SUBJECT: Grand Gulf Nuclear Station
Unit 1
Docket No. 50-416
License No. NPF-13
File 0260/L-860.0
Organization of Grand Gulf
Management and Staff,
Supplemental Information
AECM-84/0360

SUPPLEMENTARY INFORMATION ON
THE ORGANIZATION SUBMITTAL OF
MAY 24, 1984

Figure 1

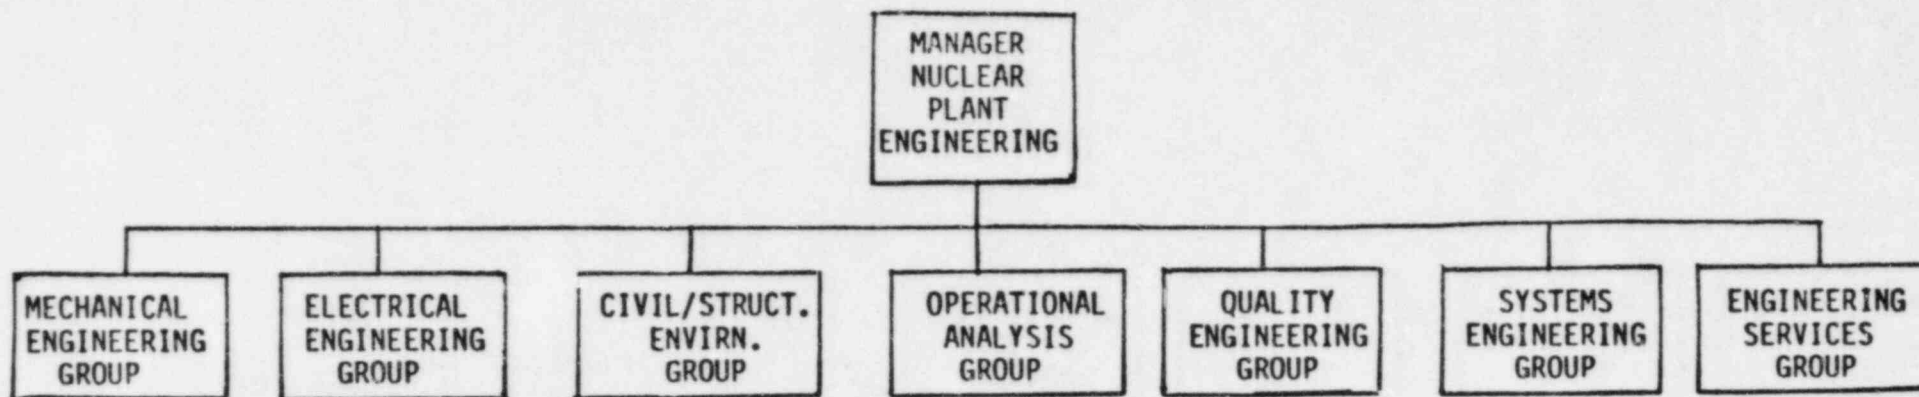
The Nuclear Plant Engineering organization has changed by the addition of two principal engineers as described above. Figure 1 shows the NPE organization.
